Re: ZC Case 06-03 -- 100 M Street, S.E.: Request for Minor Modification of Plans the Zoning Commission Previously Reviewed and Approved under Provisions of the Capitol Gateway Overlay

**100 M STREET S.E.**  
**WASHINGTON, DC**  
**OFFICE BUILDING**  
**REQUEST FOR MODIFICATIONS - ZONING**

INDEX	BOARD OF ZONING REQUEST FOR MODIFICATION SET (02/28/07)
COVER	INDEX
L-1	ORIGINAL LANDSCAPE PLAN RENDERING
L-1R	REVISED LANDSCAPE PLAN RENDERING
A-3	ORIGINAL FIRST AND SECOND FLOOR PLAN
A-3R	REVISED FIRST FLOOR PLAN
A-6	ORIGINAL PENTHOUSE - ROOF PLAN
A-6R	REVISED PENTHOUSE - ROOF PLAN
A-11	ORIGINAL EAST ELEVATION
A-11R	REVISED EAST ELEVATION
A-12	ORIGINAL WEST ELEVATION
A-12R	REVISED WEST ELEVATION

L-1R

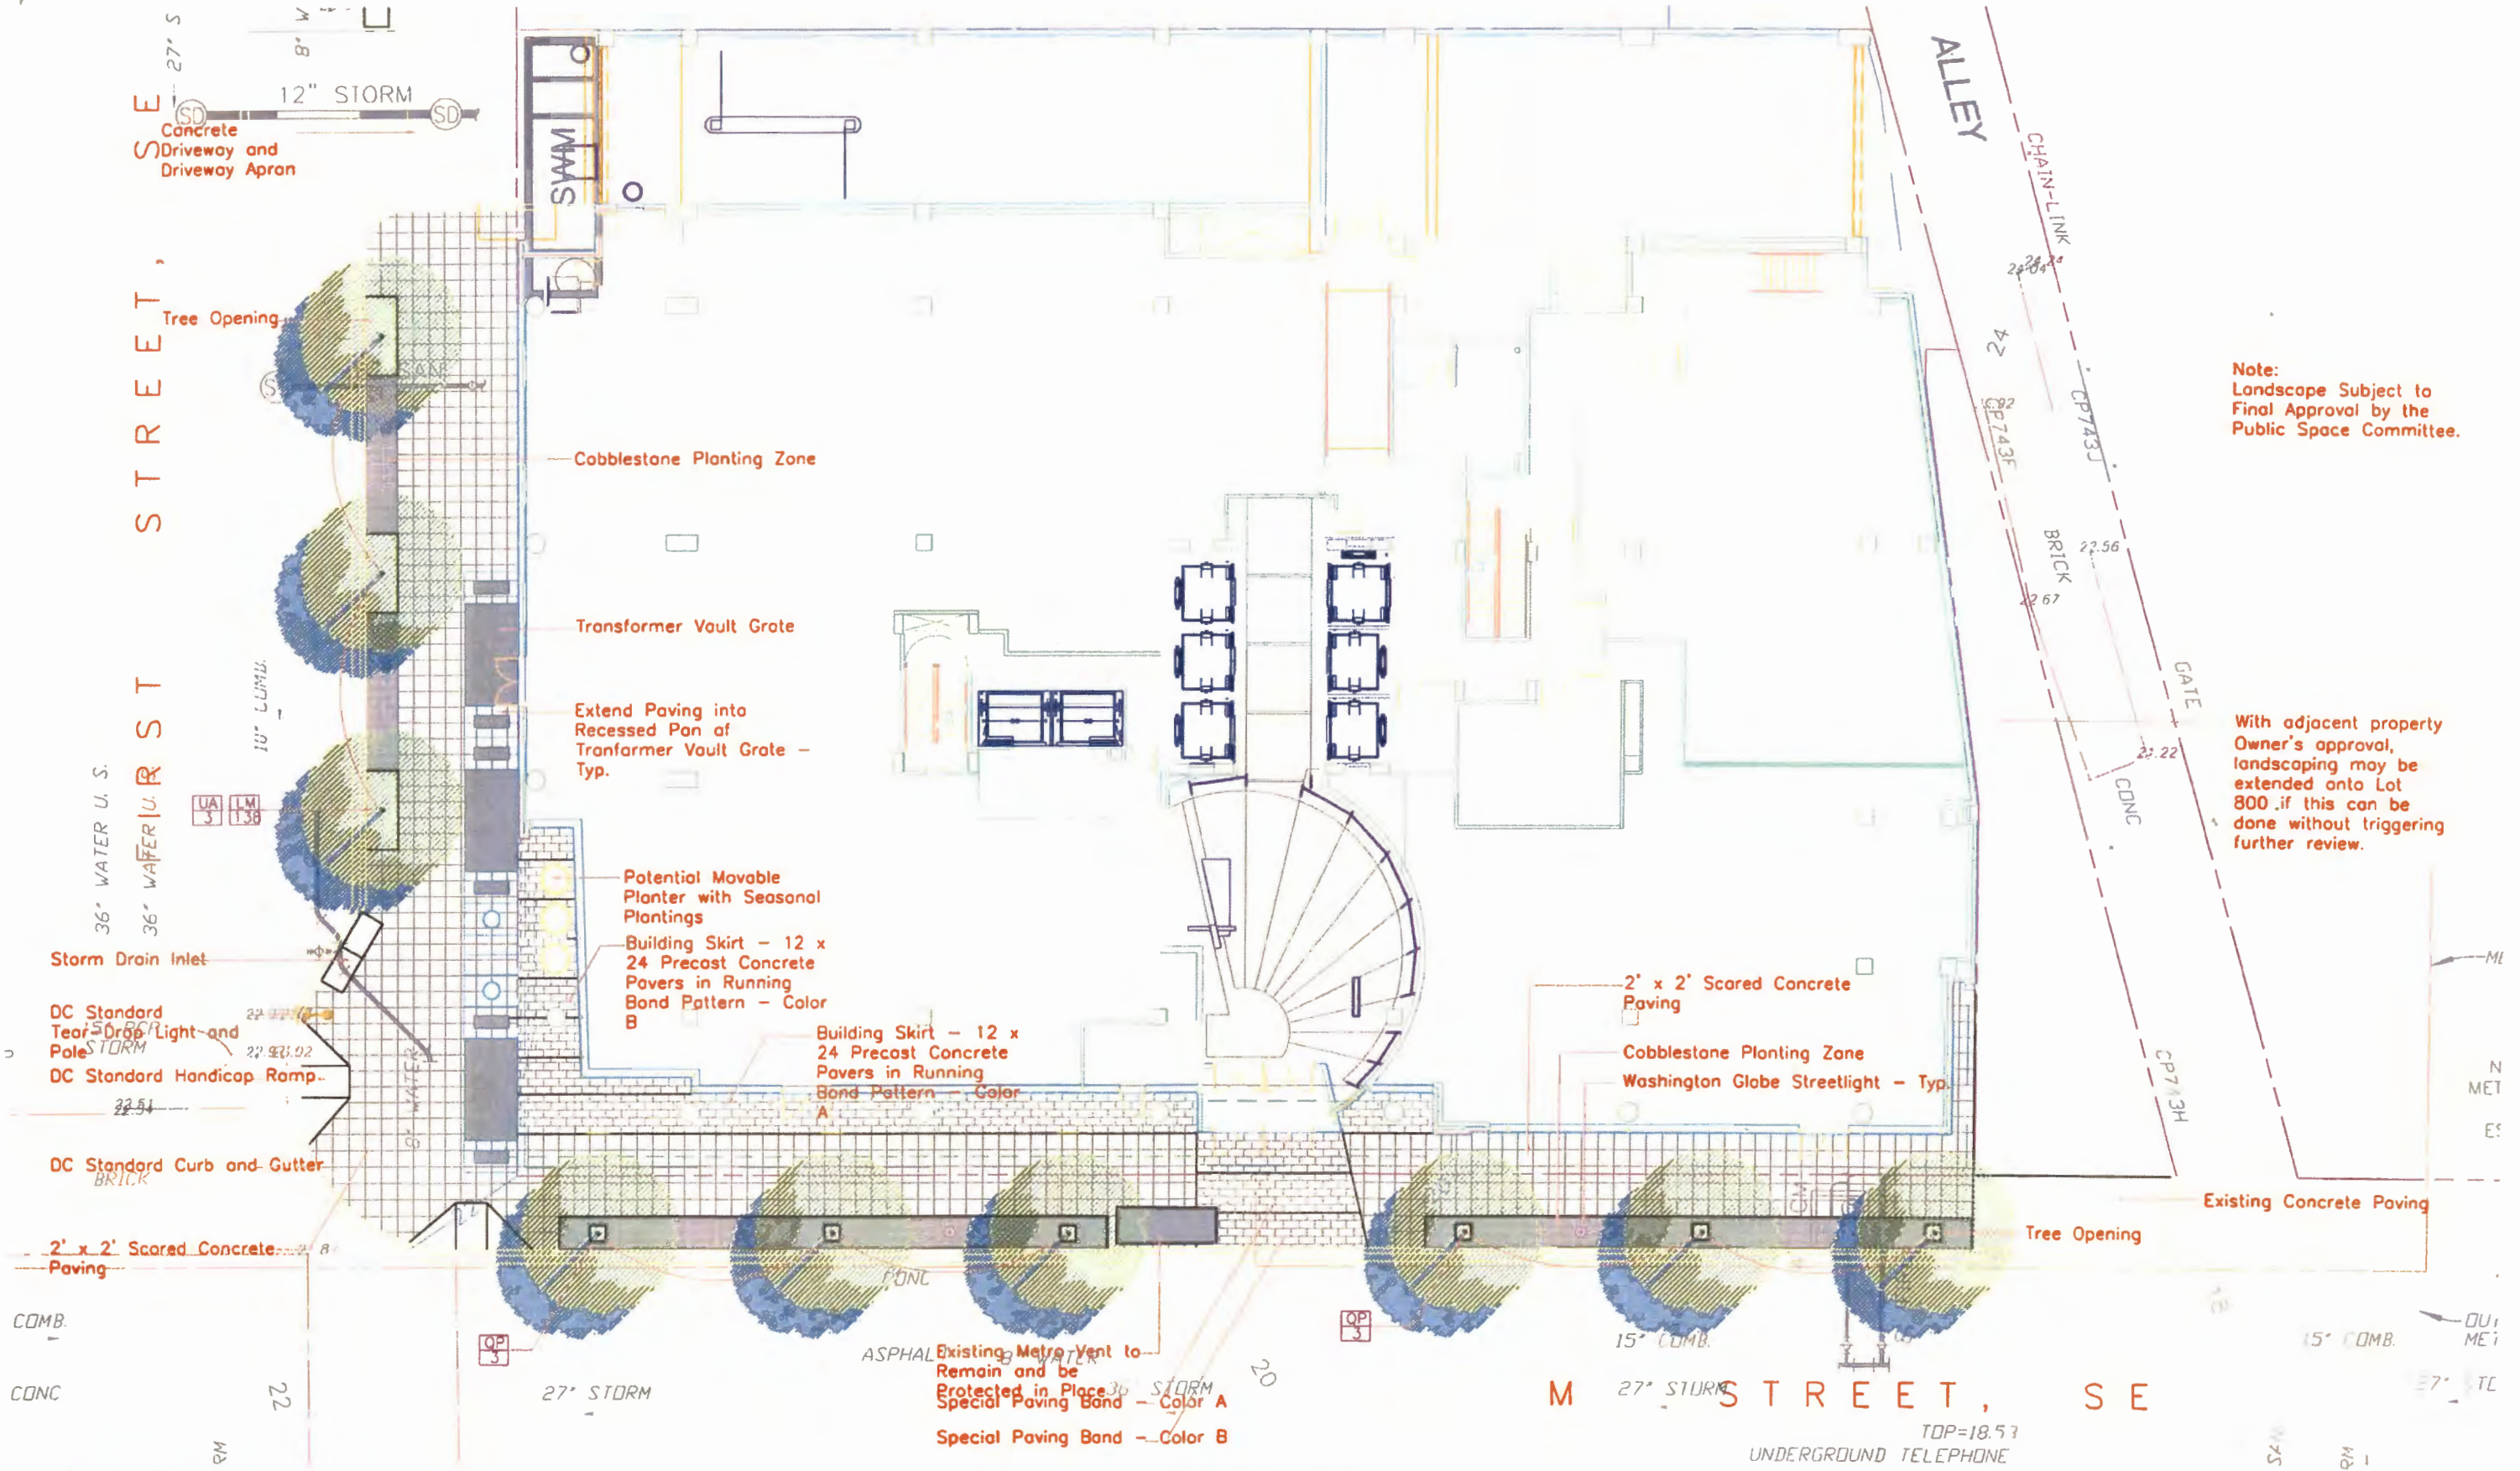
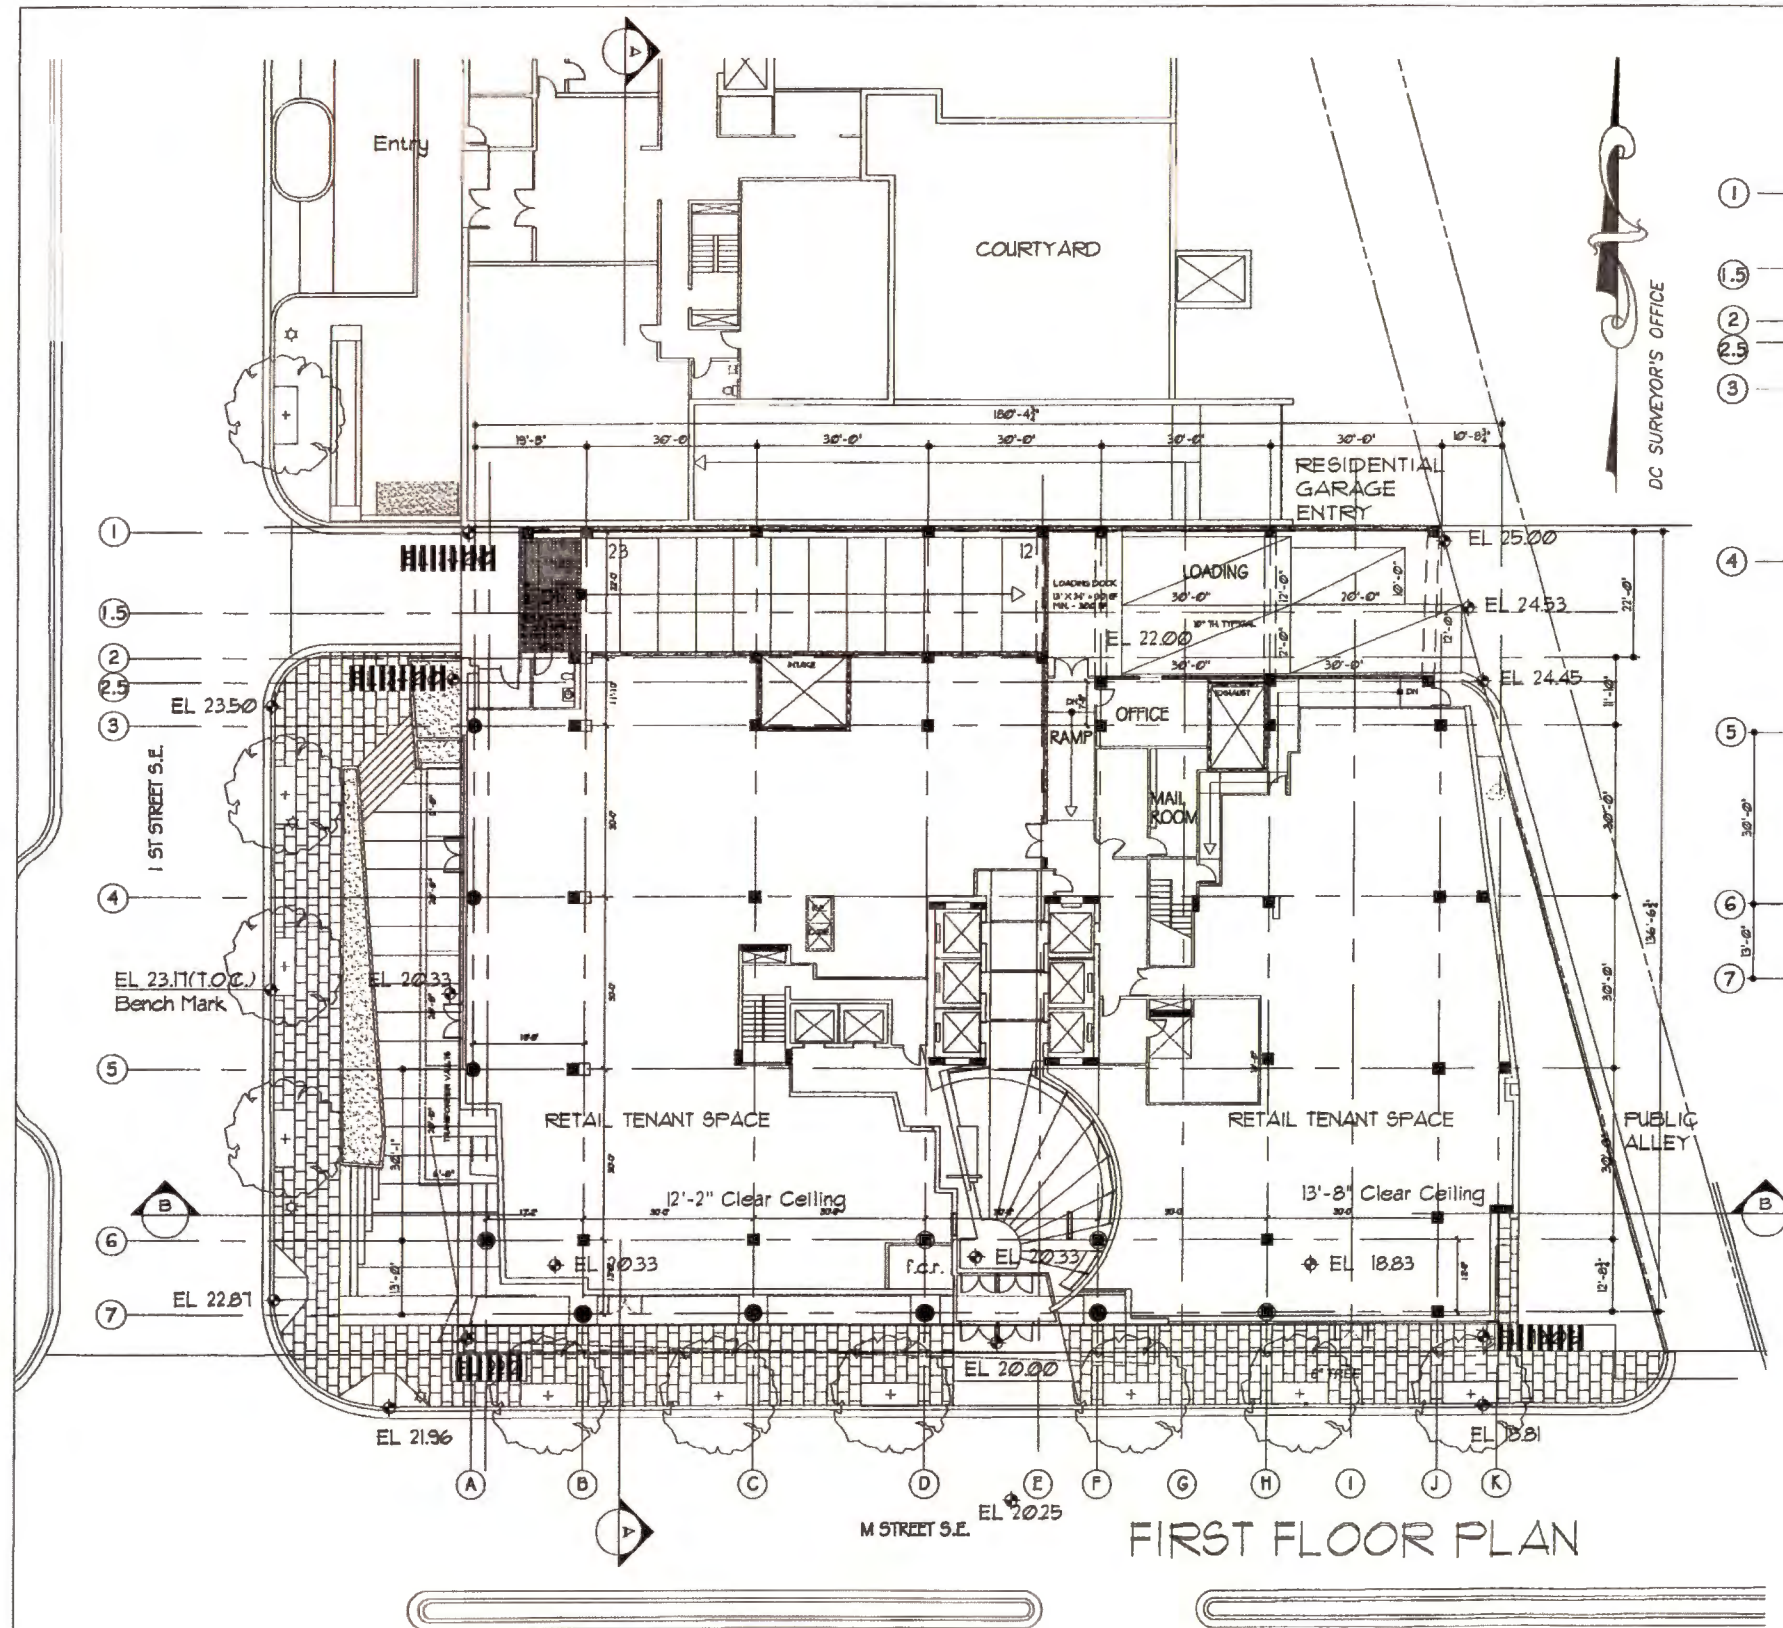
**1a. Minor Modification of Western (First Street) Façade at Ground Level and Adjacent Landscaping (Public Space):**

The Government of the District of Columbia's Department of Transportation has decided to reconstruct and widen the portion of First Street, S.E., that abuts the site as part of a larger effort related to that right of way. This widening will eliminate the "public parking" between the edge of the sidewalk closest to the building and the property line; thus, it will no longer be possible to create an outdoor seating area. The total width roadway is expanding to provide additional lanes for vehicles and bicycles. Thus, the walkway between the curb and the eastern property line is being reduced. Specifically, the total width of the combined sidewalk and "public parking" east of the "cartway" reduces from about thirty-two feet (32 ft.) to just twenty feet (20 ft.). Moreover, the plan removes all "public parking" that had previously existed between the property line and the closer edge of the public sidewalk.

The **minor modifications requested** eliminates the seating area and patio at the grade of the ground floor, raises the height of the First Street entrance door, and shortens the height of the glazing to the base of the new, higher ground level.
